BUILDING SCOPE ADDENDUM NO. 01

This Addendum is a summary of clarifications, interpretations, corrections and/or modifications to the Contract Documents for the Conestoga High School Athletic Fields Project prepared by Heckendorn Shiles Architects.

5 ENLARGED MECHANICAL 1 PLAN
E101 1/4" = 1'-0"

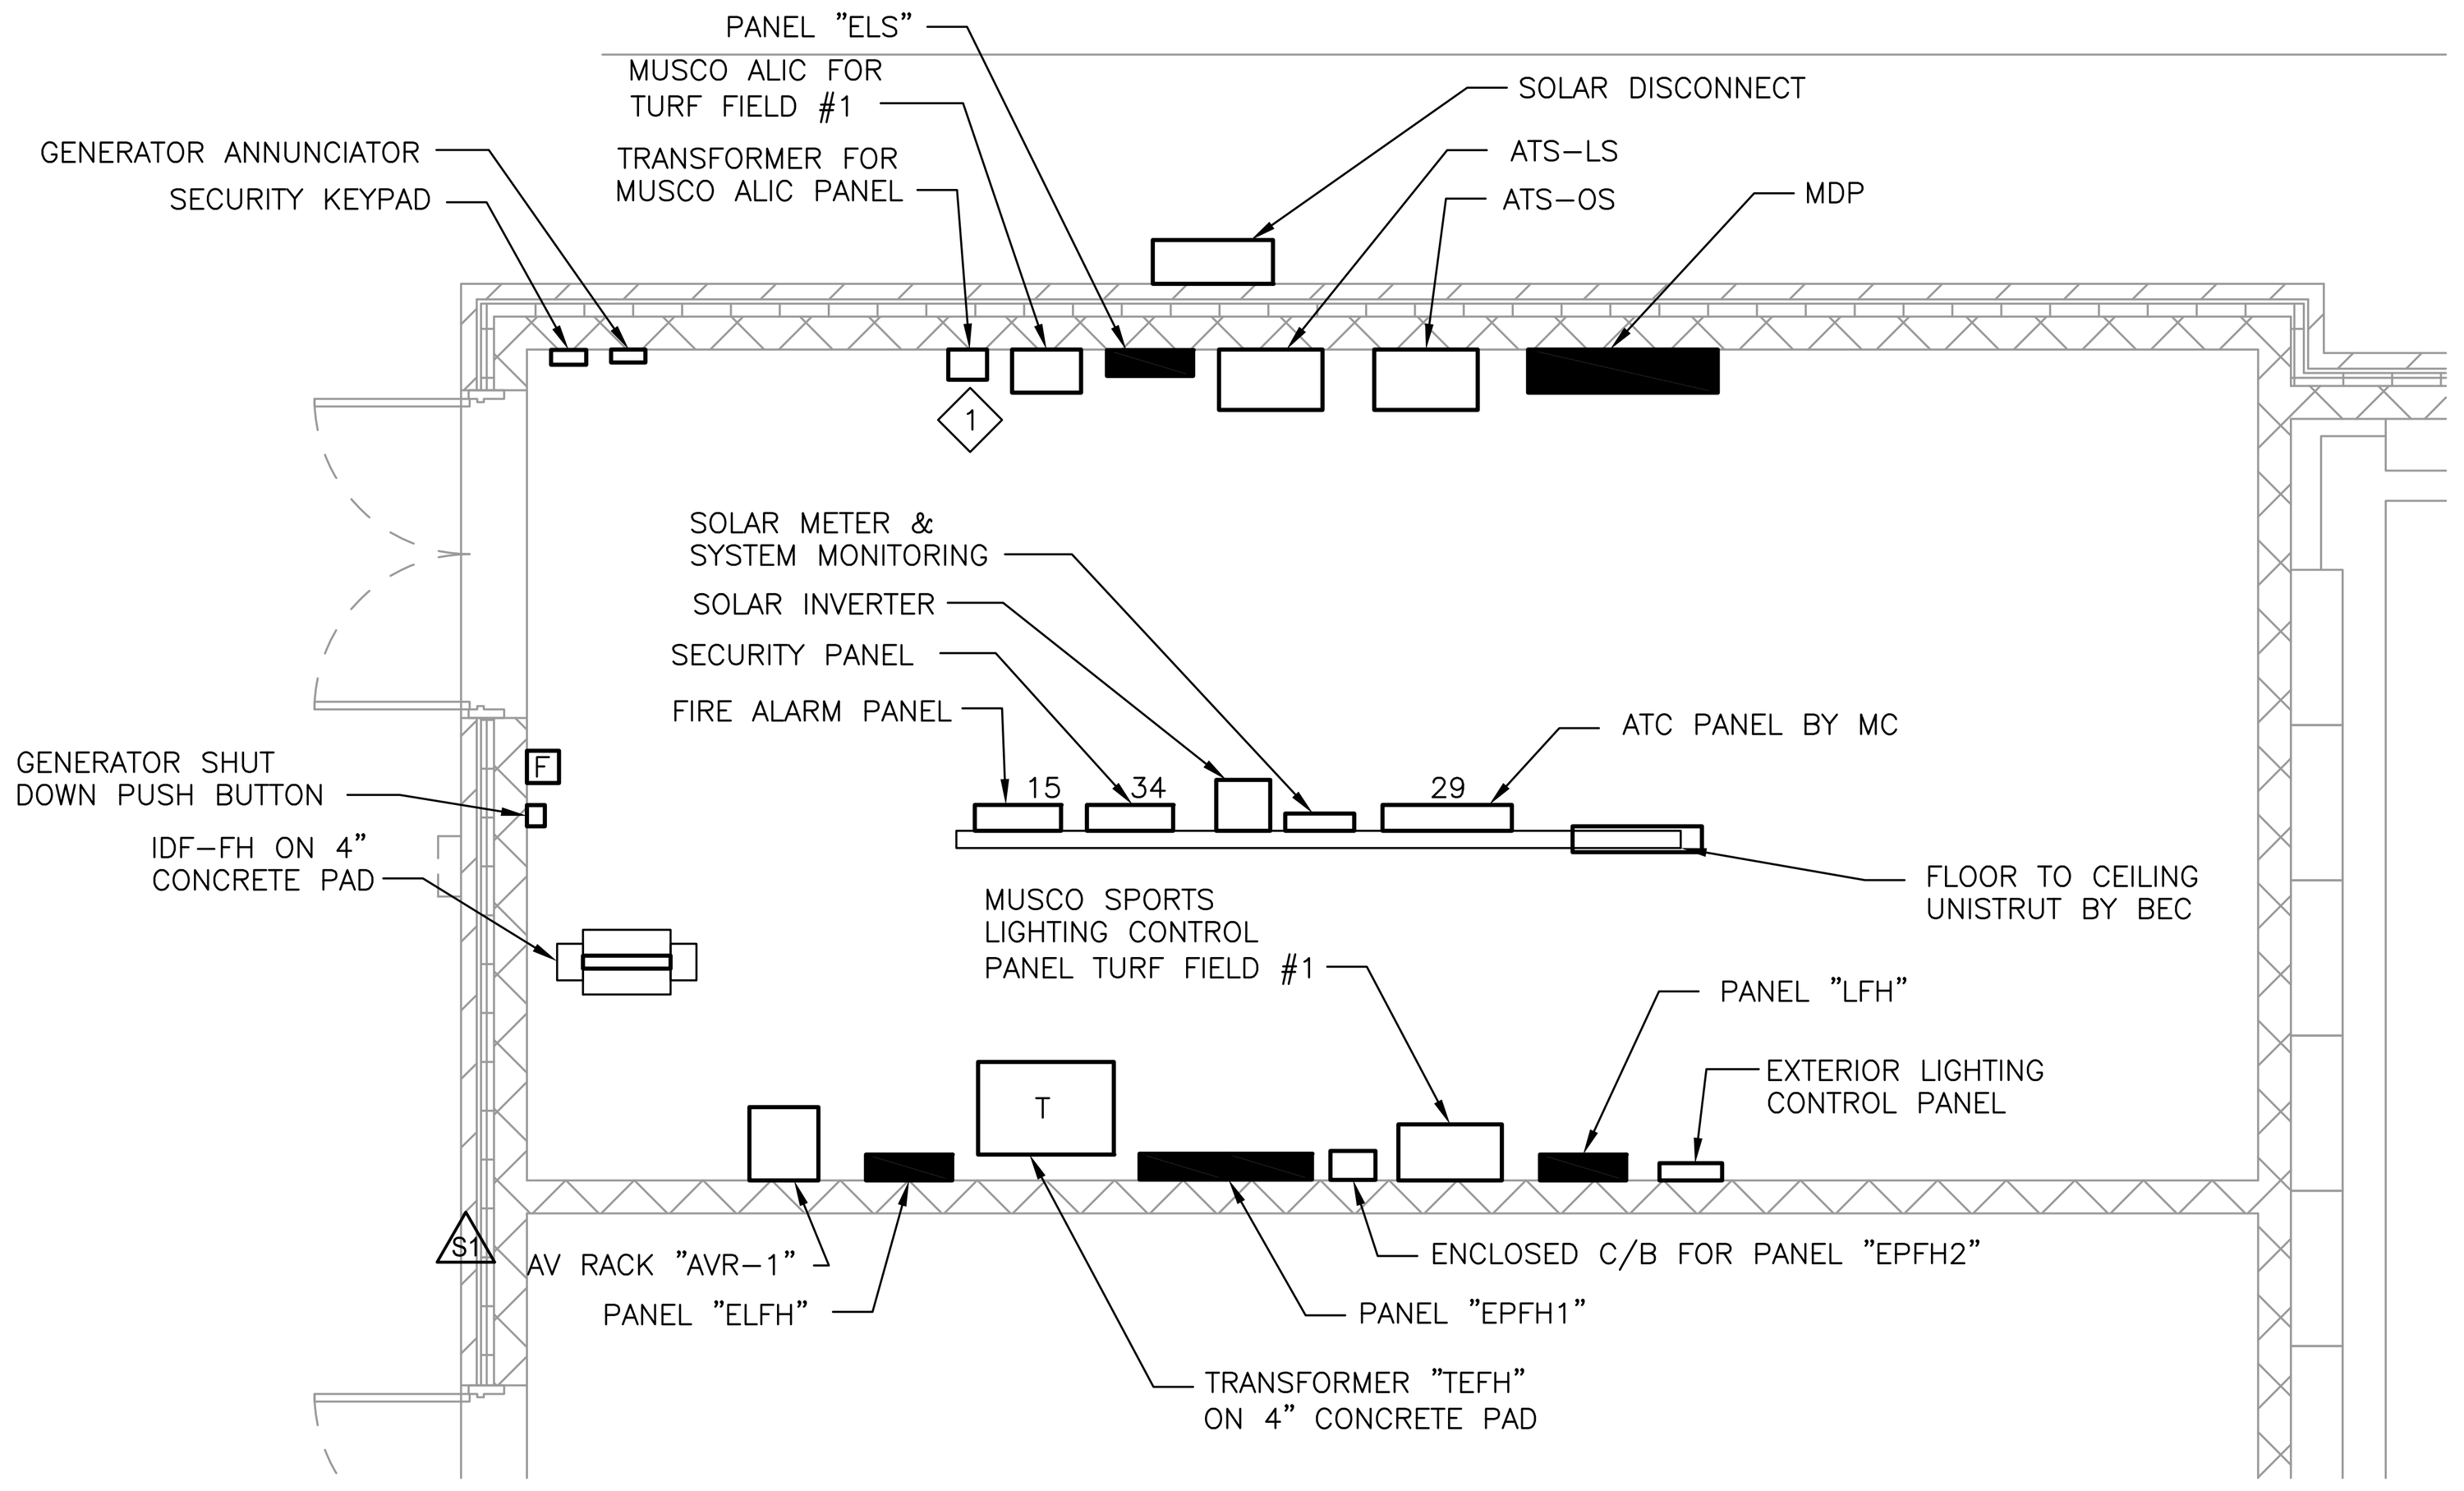
48. Question: Refer to Drawing #E101, at "LIGHTING" portion. No Exit Signs are shown. Please show Types and locations accordingly.

1. Specification - 281600 Intrusion Detection - Remove this section in its entirety.
2. Drawing – E001 Updated symbols and Contractor Responsibiliy Matrix
3. Drawing – E101 Added receptacle for AV Rack and shifted lights.
4. Drawing – E302 Added circuits for AV Rack and added additional spare breakers.

Response: Exit signs are not required.
